SERVICE INSTRUCTION

Service Instruction No. 1280D
(Supersedes Service Instruction No. 1280C)
Engineering Aspects are FAA Approved

SUBJECT: Rotator Type Intake Valves

Kit No. LW-13292 Rotator Valve Replacement for
 one cylinder consists of

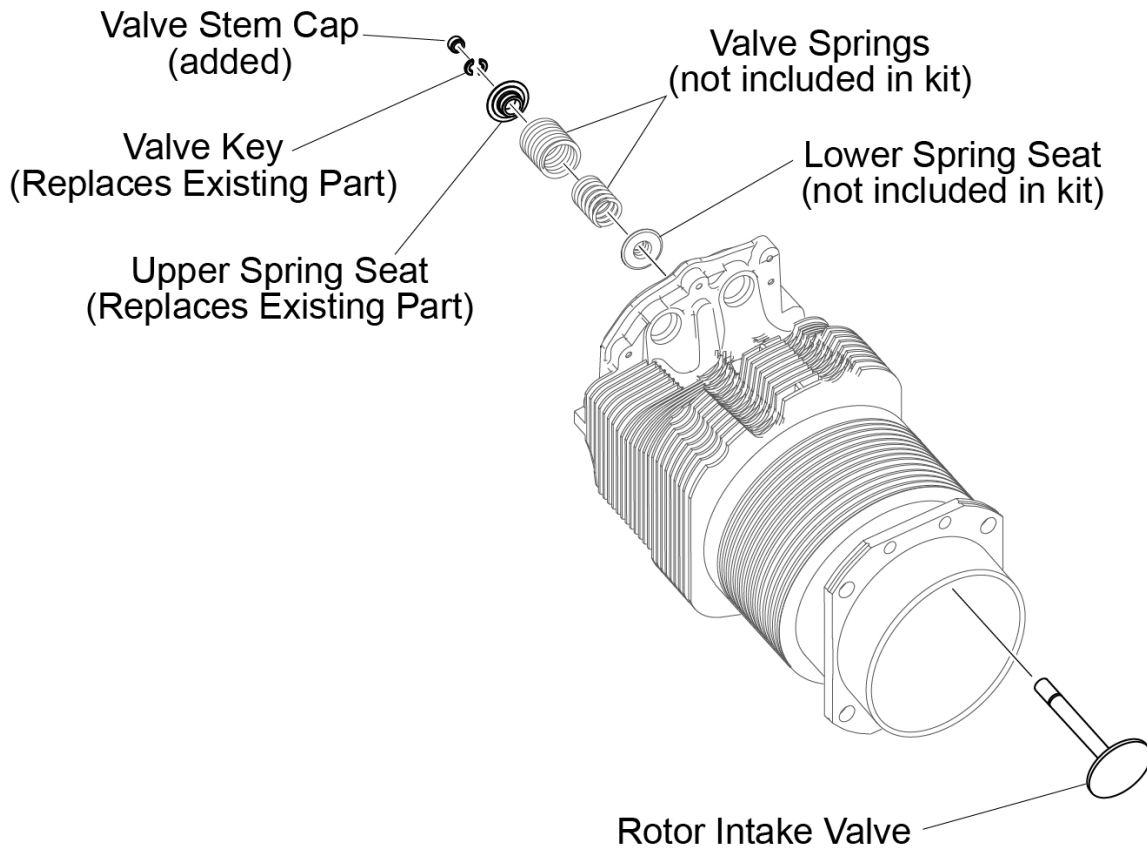
In order to improve valve seating and minimize compression loss at the intake valve seat, a new intake valve, incorporating a rotator cap is available for installation in applicable aircraft engines now in service. The specific kits contain all the needed replacement parts.

1	17A23943	Intake Valve
1	69532	Upper Spring Seat
2	72050	Valve Key
1	62388	Valve Stem Cap
